ADDENDUM
NO. 2

April 20, 2021

HANOVER CENTRAL HIGH SCHOOL ADDITIONS AND RENOVATIONS
Cedar Lake, IN 46303

Addendum Two (AD.02) to the drawings and specifications prepared by Gibraltar Design and The Skillman Corporation for **Hanover High School Addition and Renovations** for Hanover Community School Corporation, Cedar Lake, Indiana.

SHEET P-116

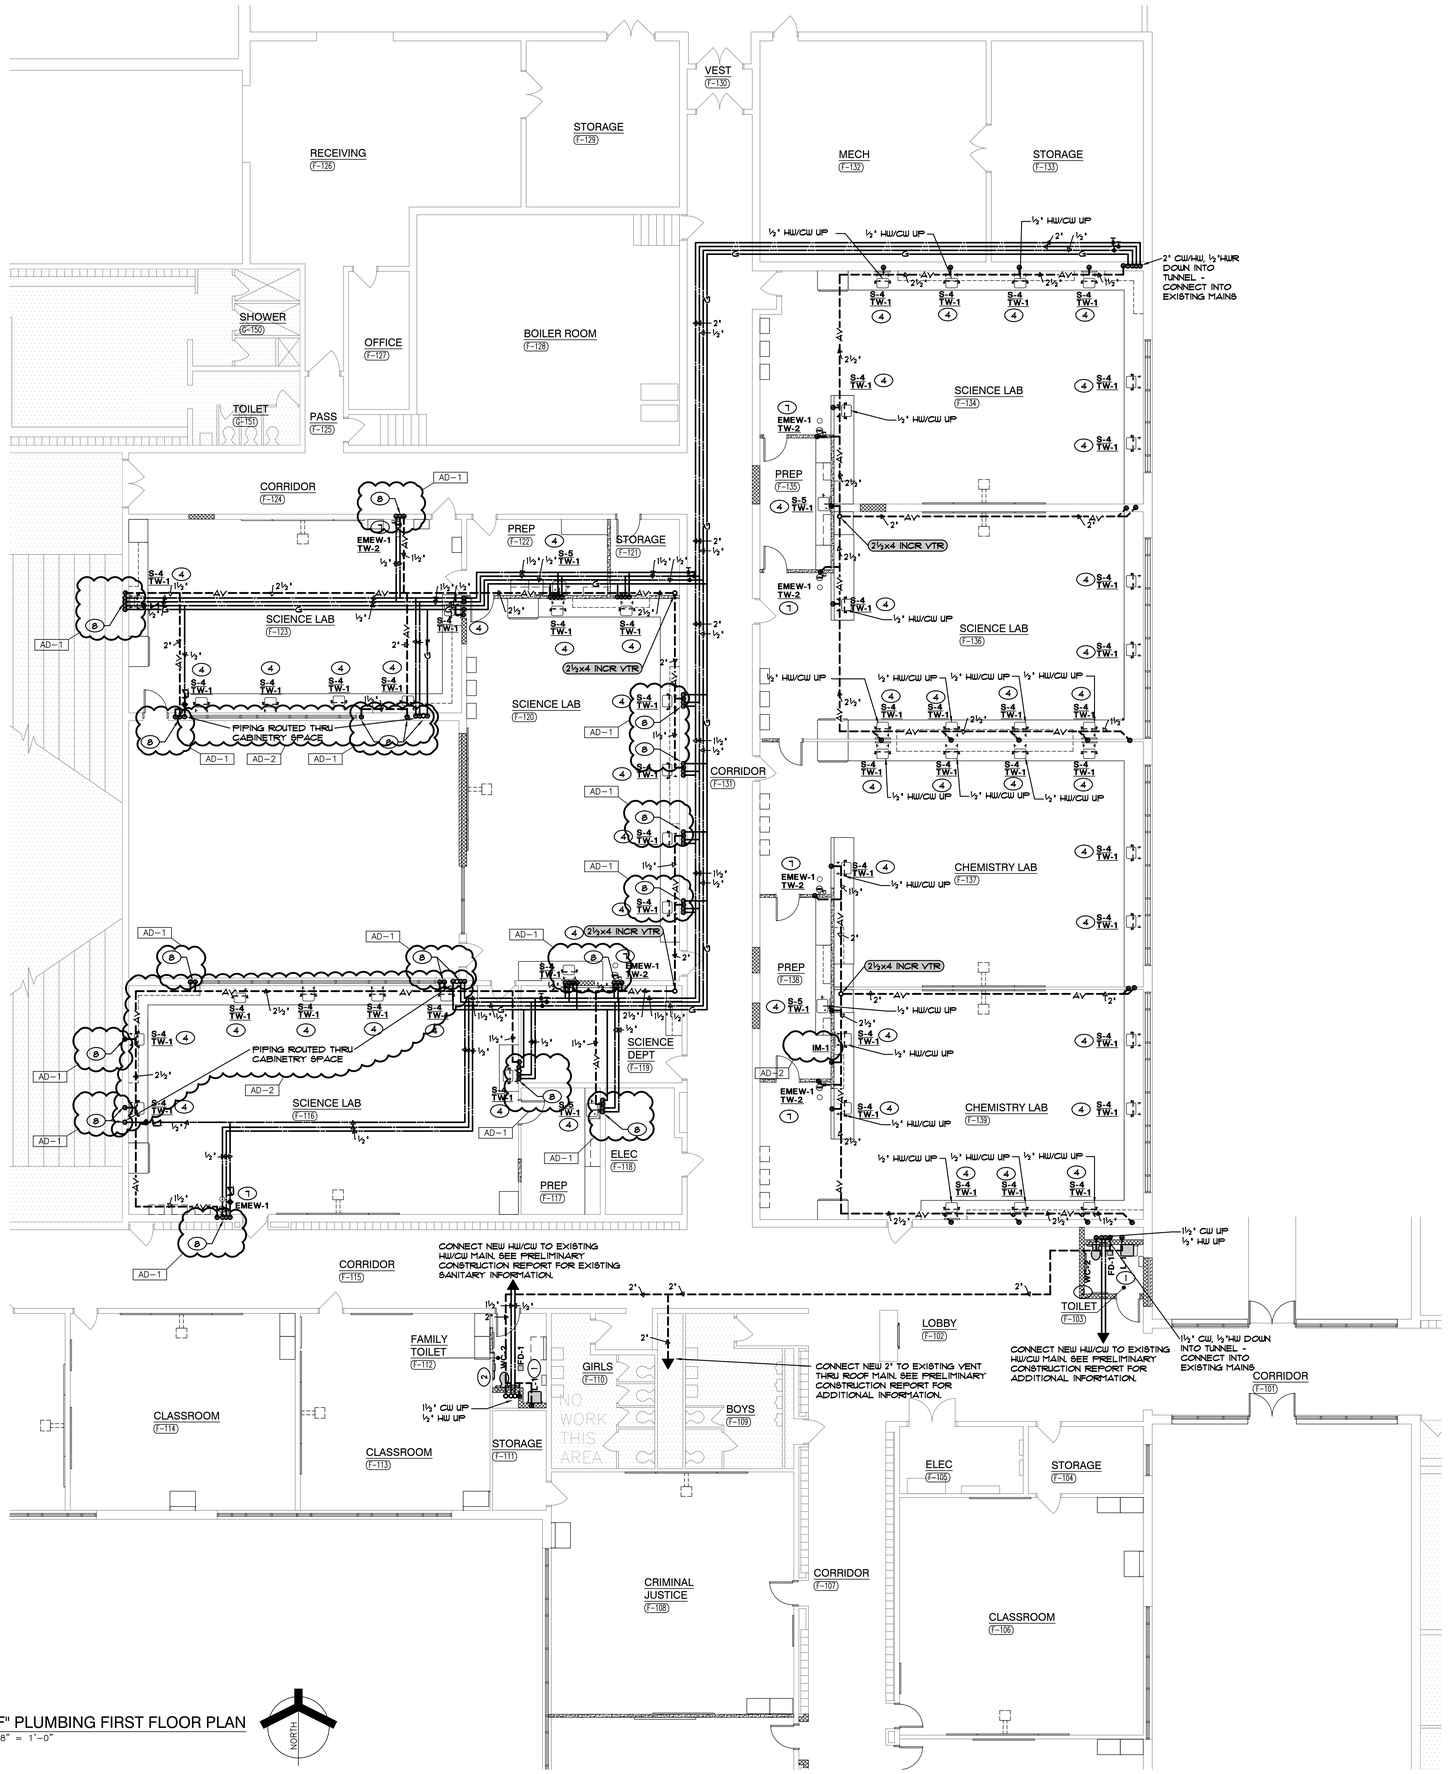
56. Sheet P-116

A. Refer to revised full-size drawing, included in this Addendum, for the following revisions:

1. Updated plumbing piping to be routed through cabinetry space.
2. Added Ice Maker in Prep F-138.

UNIT "G" PLUMBING FIRST FLOOR PLAN

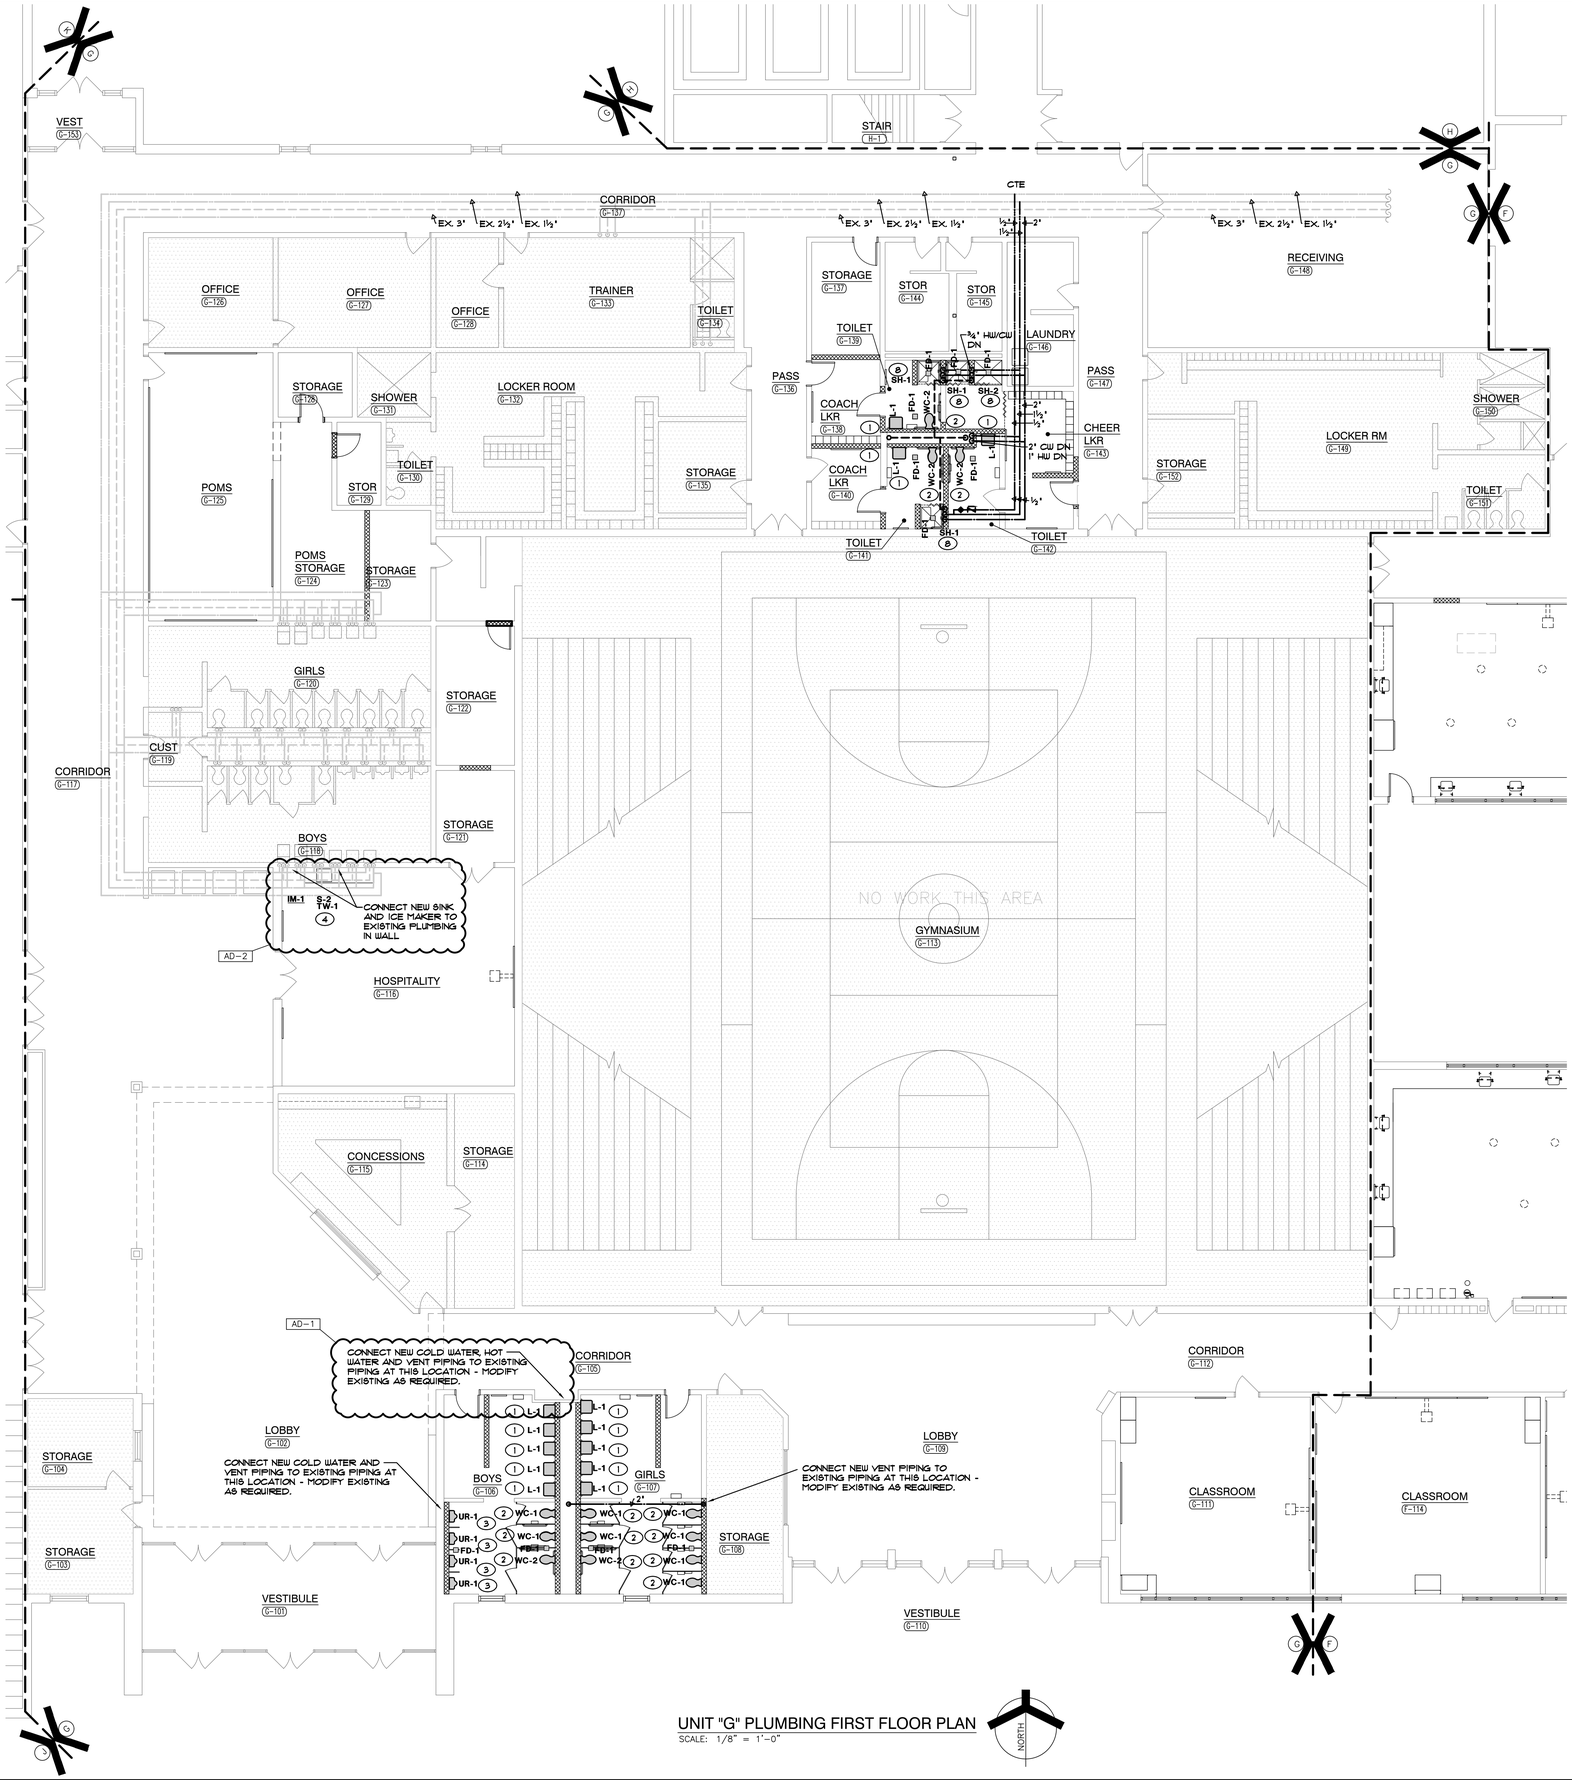
57. Sheet P-117

A. Refer to revised full-size drawing, included in this Addendum, for the following revisions:

1. Added Ice Maker in HospitalityG-116.

SHEET ED101

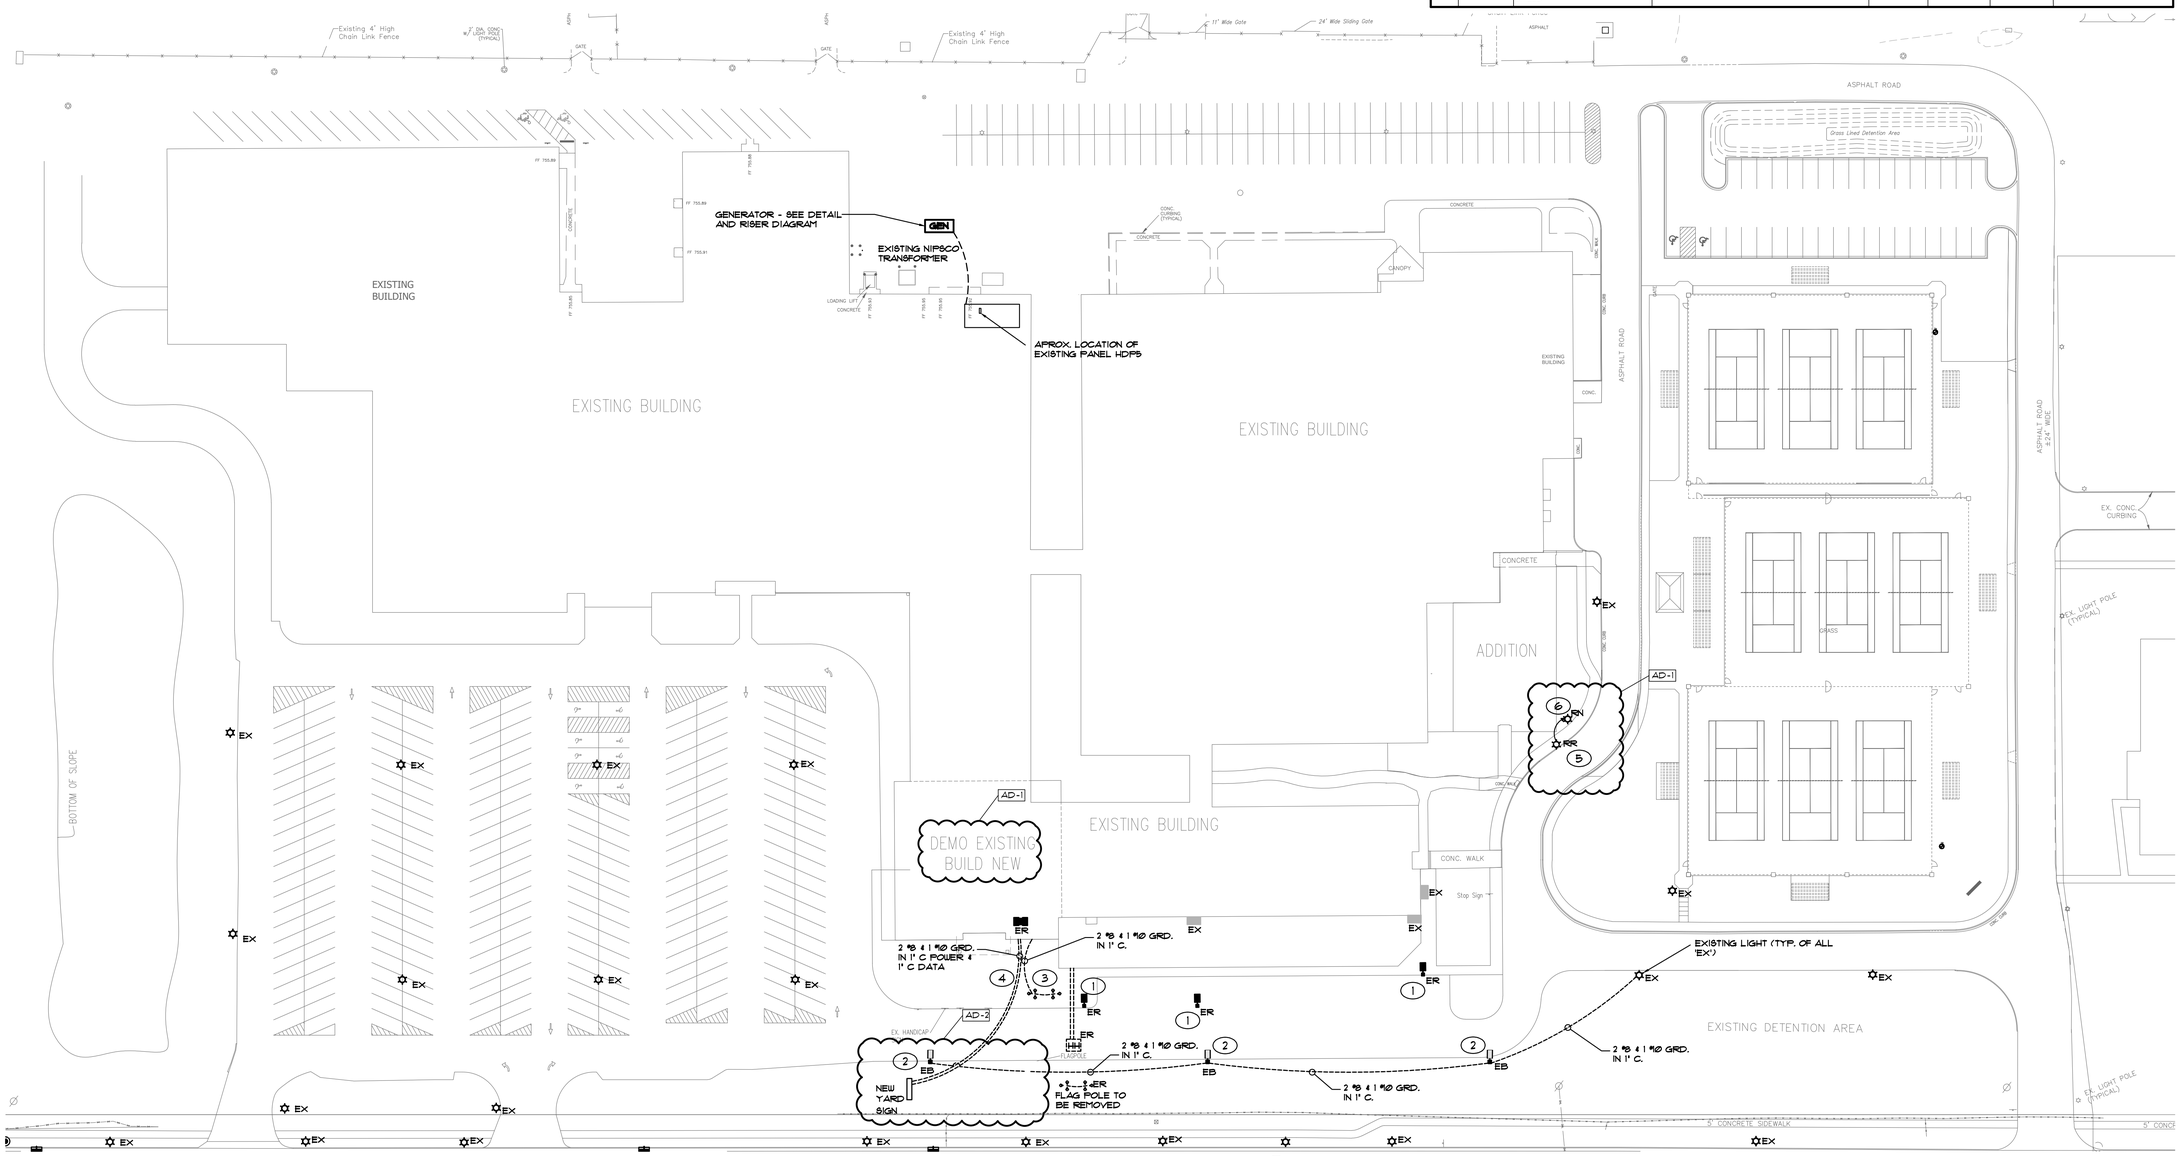
61. Sheet ED101

A. Refer to revised full-size drawing, included in this Addendum, for the following revisions:

SHEET ED103

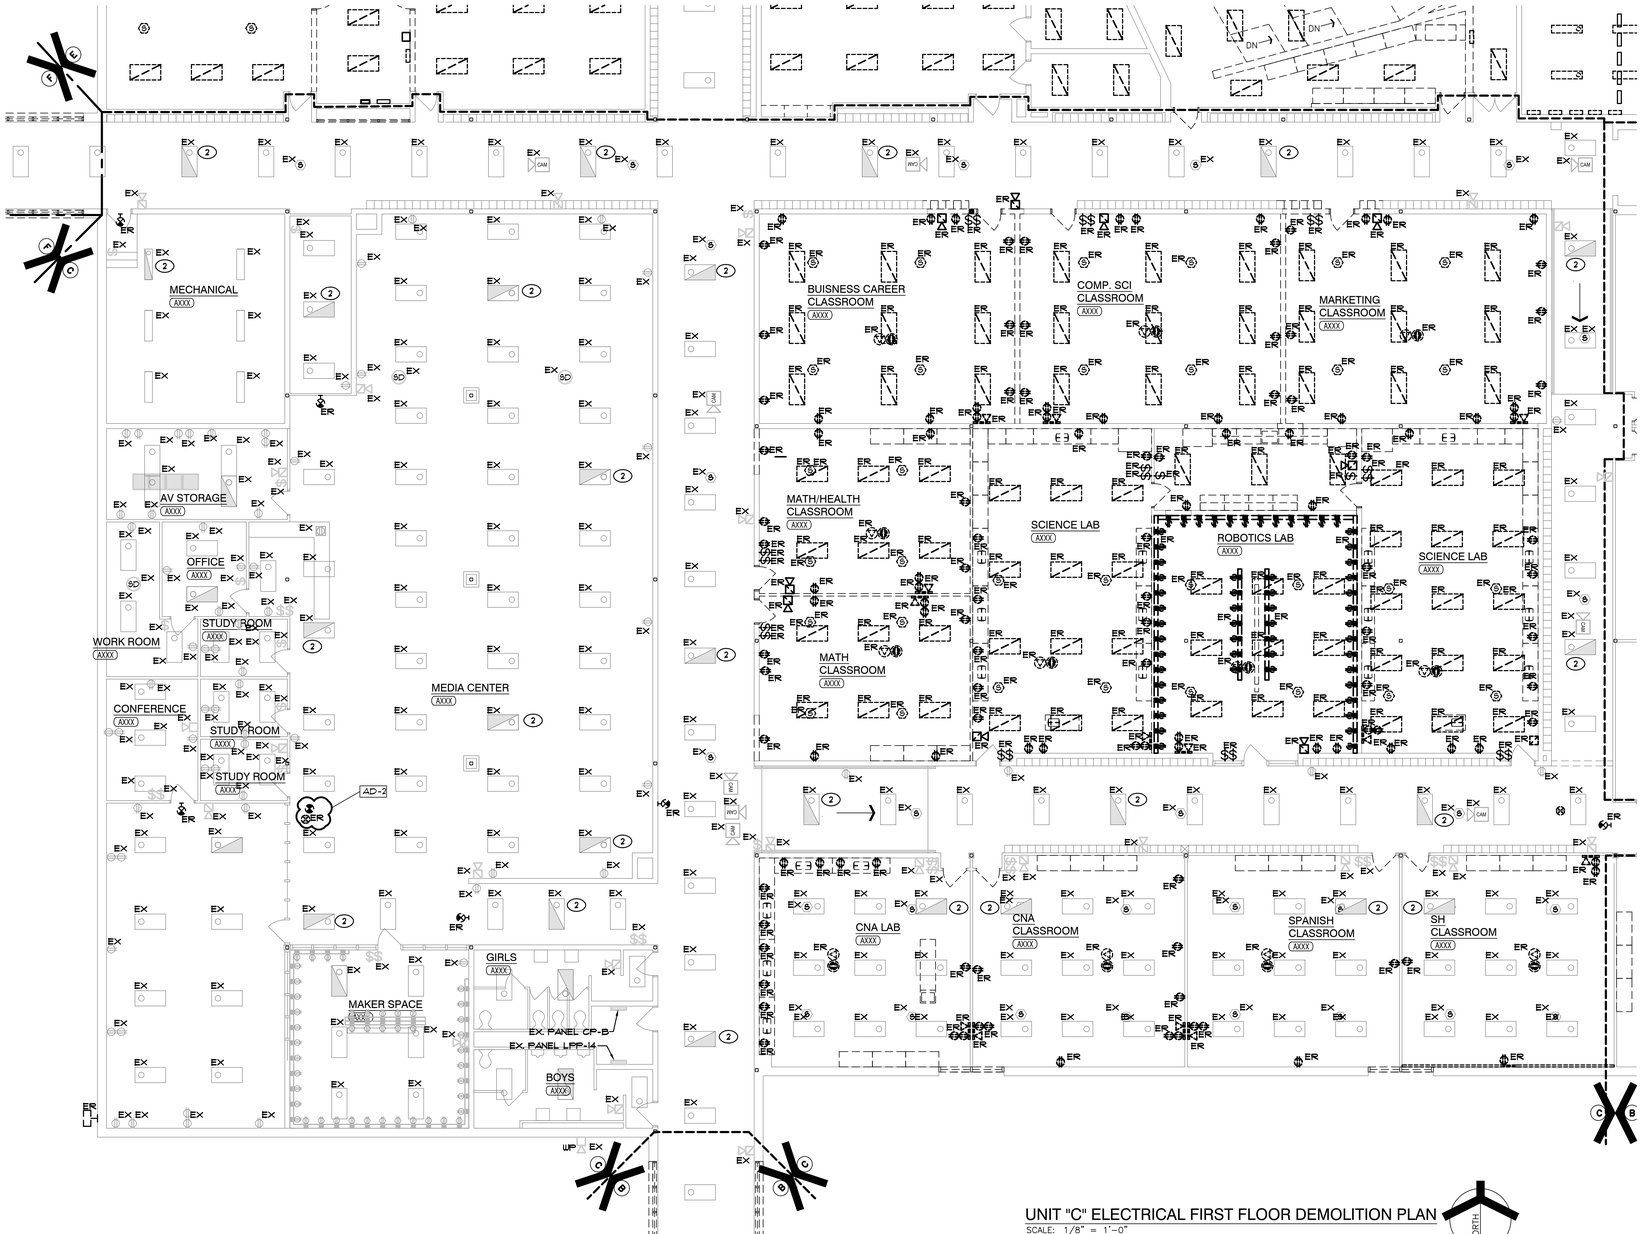
63. Sheet ED103

A. Refer to revised full-size drawing, included in this Addendum, for the following revisions:

1. Add ceiling exit sign to be replaced with new.
